75-125 HP (2-Stroke) Service Manual Correction

Description	Version	Part Number
75-125 HP (2-Stroke) Service Manual	English	90-830234R04
	International	90-892568R04

3 cylinder models

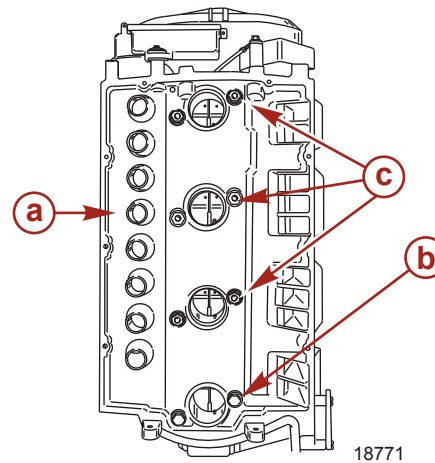
In **Section 4 - Air Box Installation**, the torques listed for the air box attaching screws and air box attaching nuts are incorrect. The incorrect torques are well above the proper torque specification. They are shown as 61 Nm (45 lb. ft.). The correct torque is: **11.3 Nm (100 lb. in.)**.

Description	Nm	lb. in.	lb. ft.
Air box attaching screw "b"	11.3	100	
Air box attaching nut "c"	11.3	100
